Subject: Response to the FCC Correspondence Reference # 31231 for additional information on RIM BlackBerry Wireless Handheld FCC ID: L6ARAR20CN, 731 Confirmation # EA300691.

The following addresses the comment on your **Correspondence Reference # 31231**, dated July 26, 2006.

Input level measurement analyzer plots for the sinusoidal 1.025 kHz signal

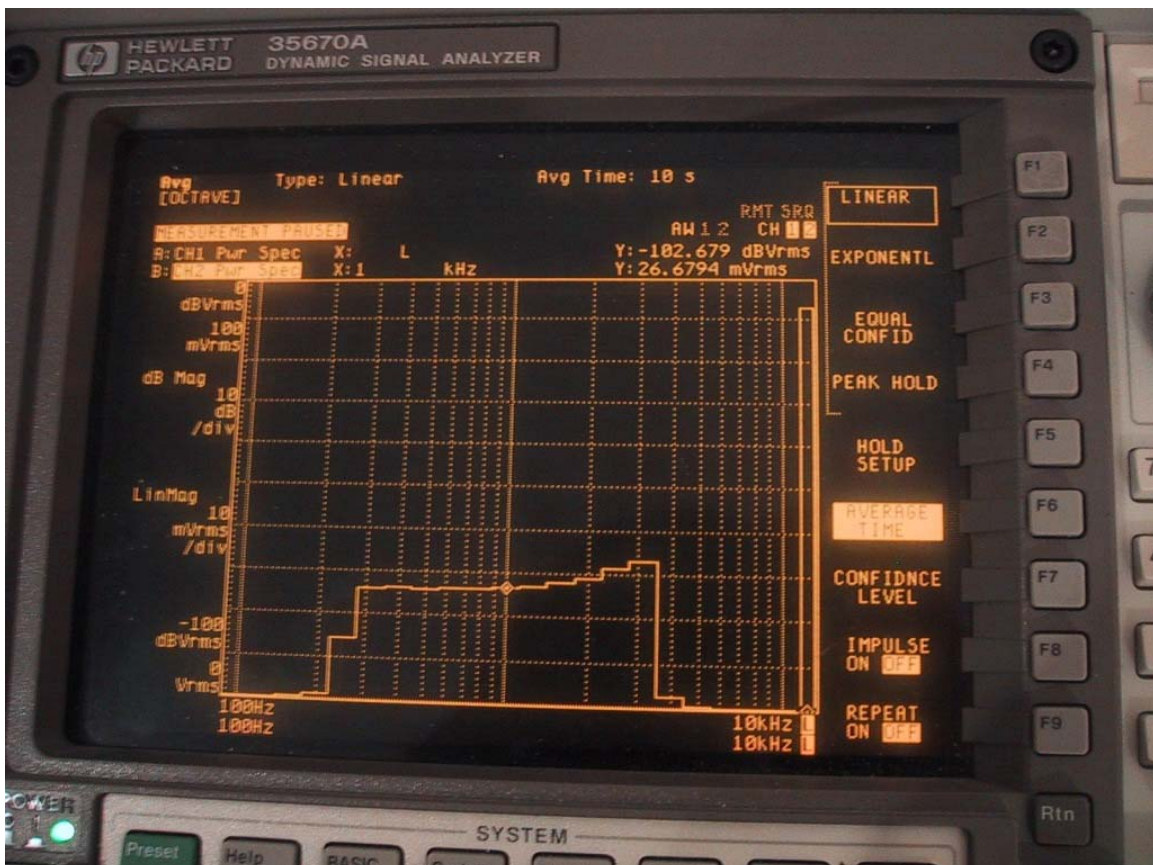
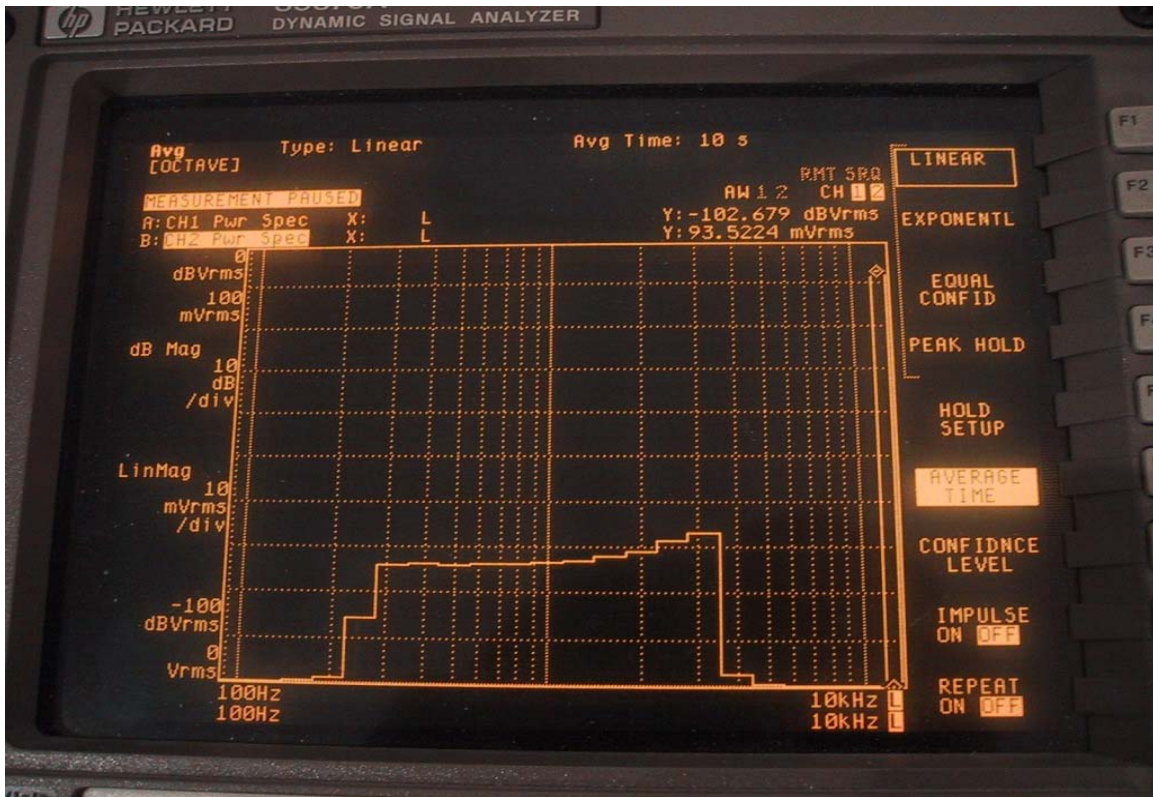
A) Regarding your answer to question 1 Please update the report to list file lengths, averaging times and any other measurement specific related information such as BWC for all measurements. Please include measurement of the input reference level. Please also specify averaging times for ABM2. Related textual explanations should be comprehensive and clear. FYI Please note that integration times for the measurement should typically be equal to that used for the reference level measurement.

Time averaging was used with an artificial speech based signal when setting the input reference level. The averaging period was adequate to cover the signal period and the averaging method was the same for setting the reference level and performing the measurement.

A Dynamic Signal Analyzer was used to measure the time averaging of the speech-simulated signal. The analyzer was set to measure the audio signal at 1/3 octave with 10 seconds time averaging. The speech simulated signal duration is 2 seconds and the sinusoidal signal duration is 10 seconds. The DASY4 program was set to repeat the audio file while performing time averaging.

Please see new plots for the input signal measured with external analyzer DASY4 software:

The following are ABM2 measurement data and plots for supported speech service options, vocoder type and RF channel to show justification:

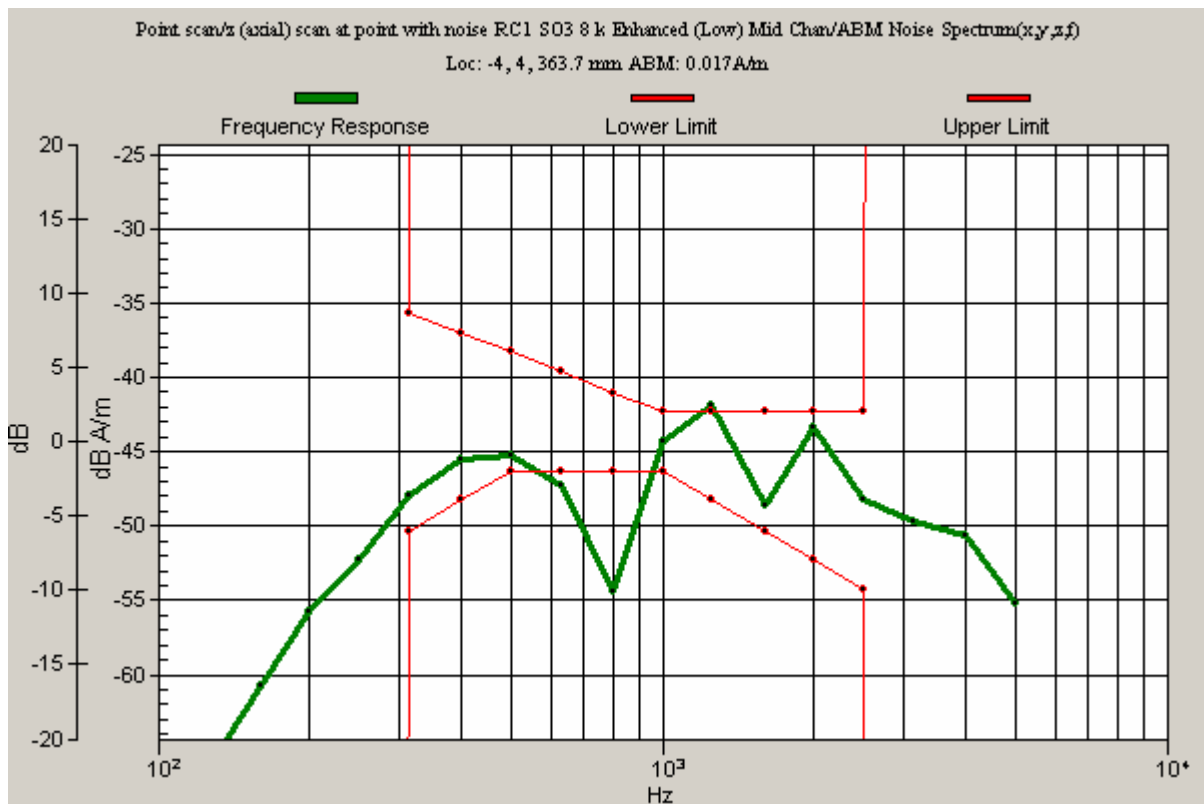
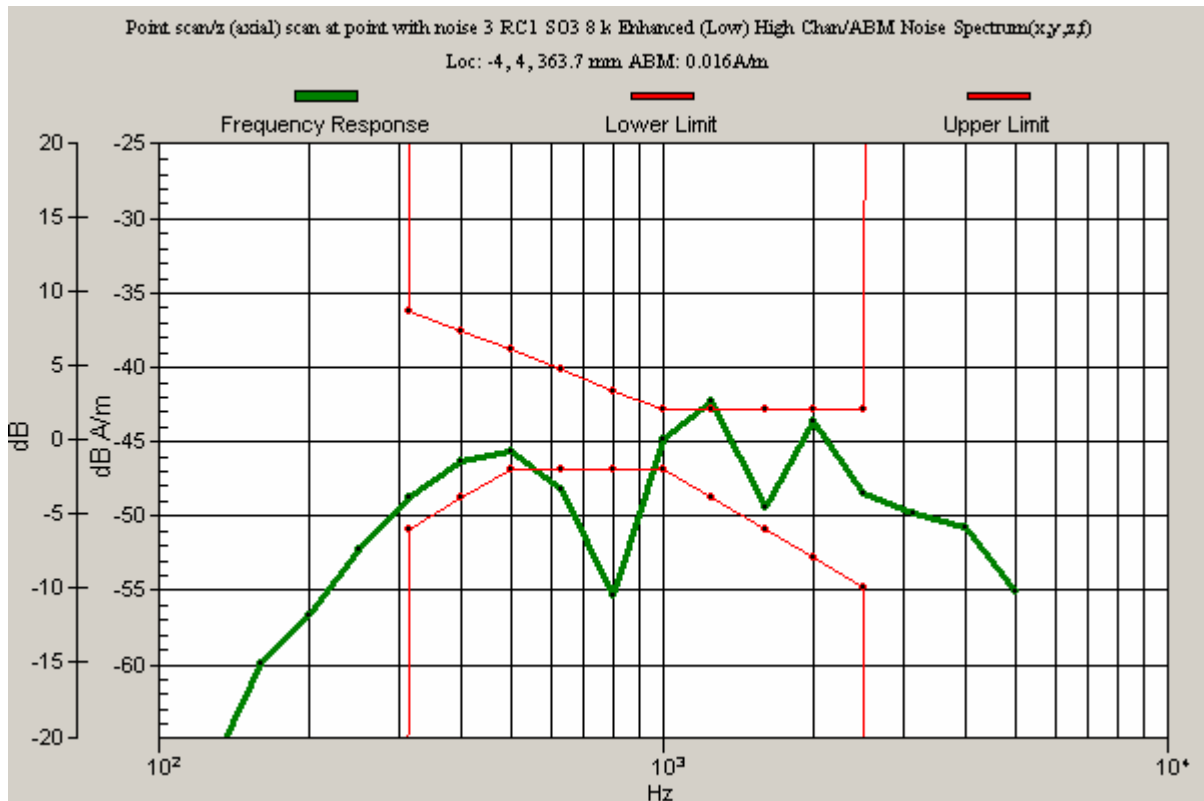
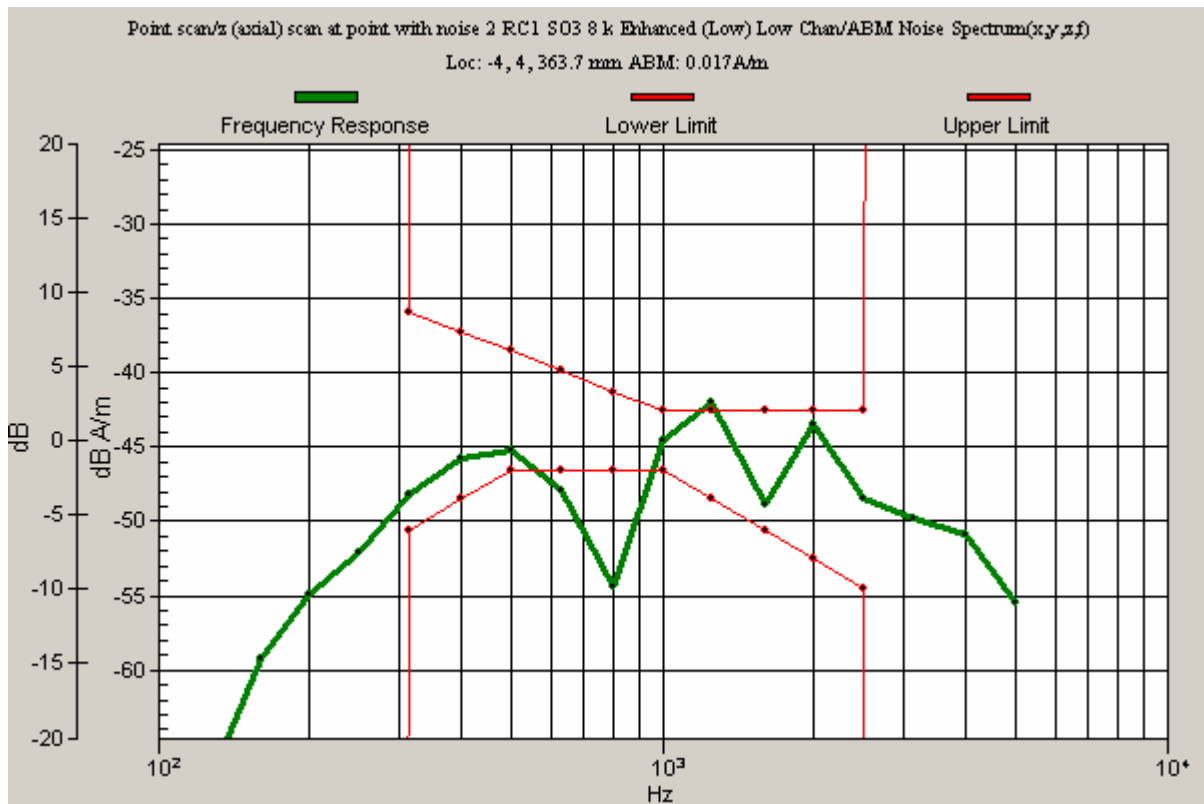
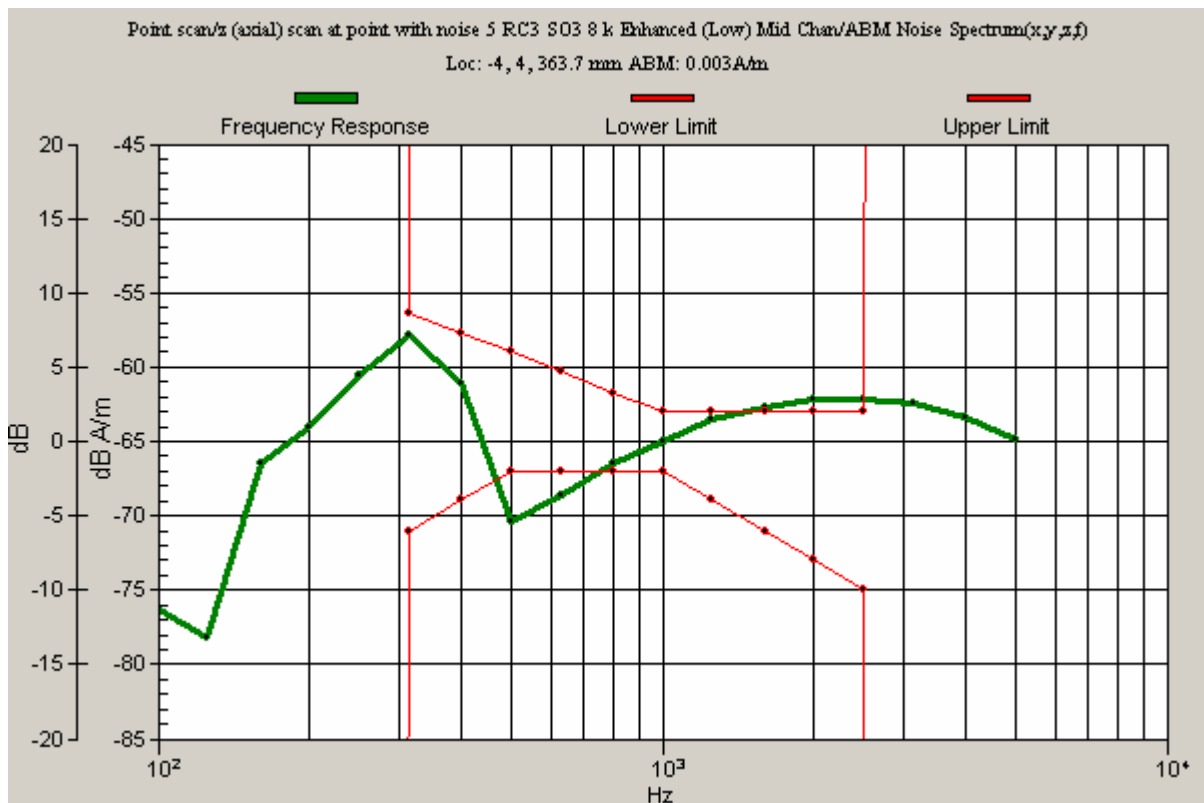
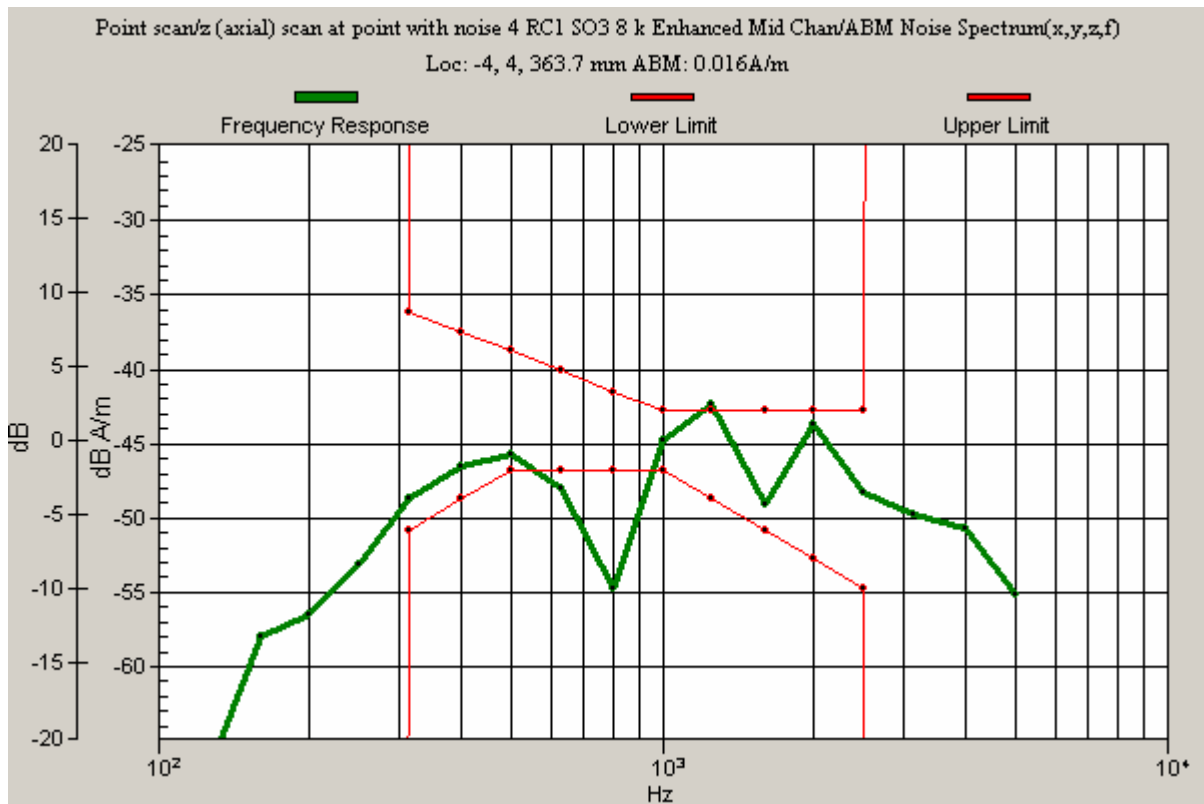
C) Regarding your answer to question 3. Please readdress. The procedure mentioned pertains to SAR testing not HAC. Please justify the subset tested in accordance with the FCC 3G procedure for HAC. Also, you mentioned that the device has both 8K enhanced and 8K enhanced low. Please address both or justify subset testing.

These were evaluated and the worst case ABM2 was determined to be RC1, SO3 and 8k Enhanced (Low), mid channel.
In addition, the RF environment (M rating) for T-Coil rating was determined by evaluating 1/8 th rate RC1, SO2 option. This option does not have a vocoder to perform ABM measurements.
